ULNRC-05242

**DOCKET NUMBER 50-483
CALLAWAY PLANT UNIT 1
UNION ELECTRIC CO.
FACILITY OPERATING LICENSE NPF-30
RESPONSE TO REQUEST FOR ADDITIONAL INFORMATION REACTOR
COOLANT SYSTEM LEAKAGE DETECTION INSTRUMENTATION**

RESPONSES TO REQUEST FOR ADDITIONAL INFORMATION

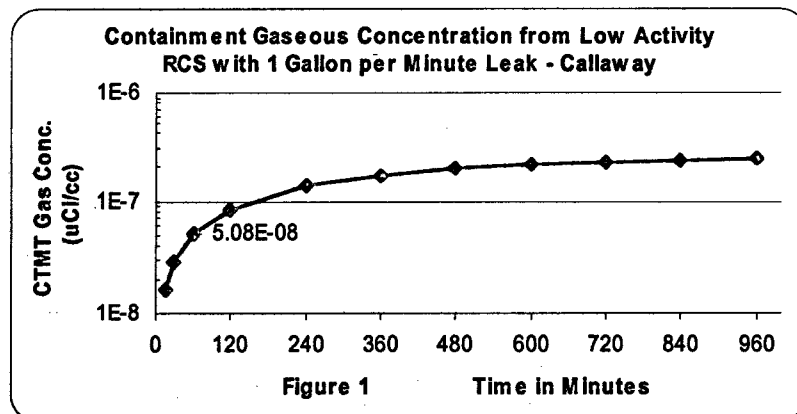
An evaluation performed in 2003 using current RCS activity levels resulted in a containment gaseous concentration at the end of 60 minutes to be $\sim 5.1\text{E-}08 \mu\text{Ci}/\text{cm}^3$ (see Figure 1 below). This evaluation confirmed the insensitivity of the containment atmosphere gaseous channels to low RCS activity.
